Access Compliance Report

Public Rights-of-Way

Intersection ID: 49395	Main Street: ROMANA_RED_LN	Cross Street: DAMASCUS_ST	Location: SE
ADA ID: 7B7A98D65F0B	Ramp Type: PerpDiag	Initial Pass/Fail: Pass	Overall Compliance: No
Codes/Mitigation Info/Possible Solution		Field Measurements/Component Compliance	
Severity Score: 12.75

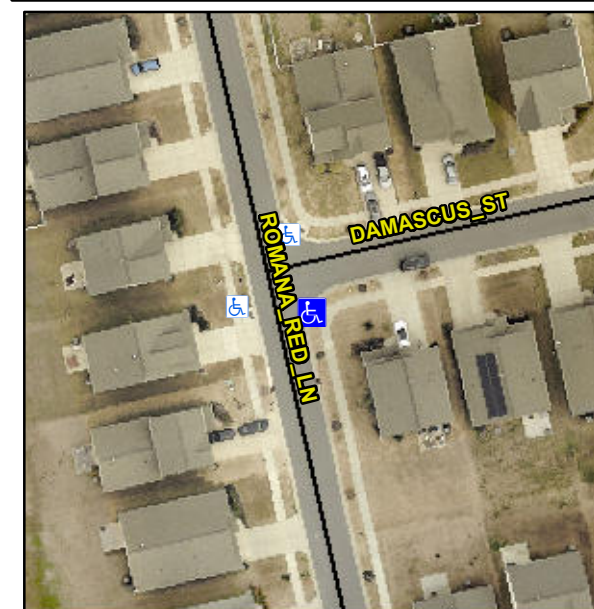
Not Found, R304.5.3, R305.2, R302.7.2, R304.5.4

Compliance	Description	Data	Compliance	Description	Data
N/A	Ramp Length (in)	73.0	Yes	Ramp Slope (%)	6.3
Yes	Ramp Width (in)	48.0	No	Ramp XSlope (%)	2.6
N/A	Flare Type LT	Sloped	N/A	Flare Type RT	N/A
N/A	Flare Slope LT (%)	3.1	N/A	Flare Slope RT (%)	6.9
N/A	Flare Traversable LT?	No	N/A	Flare Traversable RT?	No
Yes	Landing Length (in)	57.0	Yes	DWS Provided?	Yes
Yes	Landing Width (in)	48.0	Yes	DWS Contrast?	Yes
Yes	Landing Slope (%)	1.2	Yes	DWS Length (in)	24.0
No	Landing X Slope (%)	4.6	Yes	DWS Full Width?	Yes
N/A	Landing Curb? (Y/N)	No	No	DWS Offset (in)	5.5
N/A	Shared Landing?	No			
Yes	Gutter Ponding?	No	No	Gutter Slope (%)	10.1
No	Gutter Lip Ht (in)	0.5	No	Gutter X Slope (%)	5.0
N/A	Painted X Walk1?	No	N/A	Painted X Walk2?	No
	X Walk 1 Direction	To N		X Walk 2 Direction	To W
N/A	X Walk 1 Width (in)	N/A	N/A	X Walk 2 Width (in)	N/A
	X Walk 1 Slope (%)	3.4		X Walk 2 Slope (%)	0.9
	X Walk 1 X Slope (%)	1.0		X Walk 2 X Slope (%)	2.4

Remove & Replace Curb Ramp With Two New Directional Ramps or Equivalent. Remove & Replace Gutter.
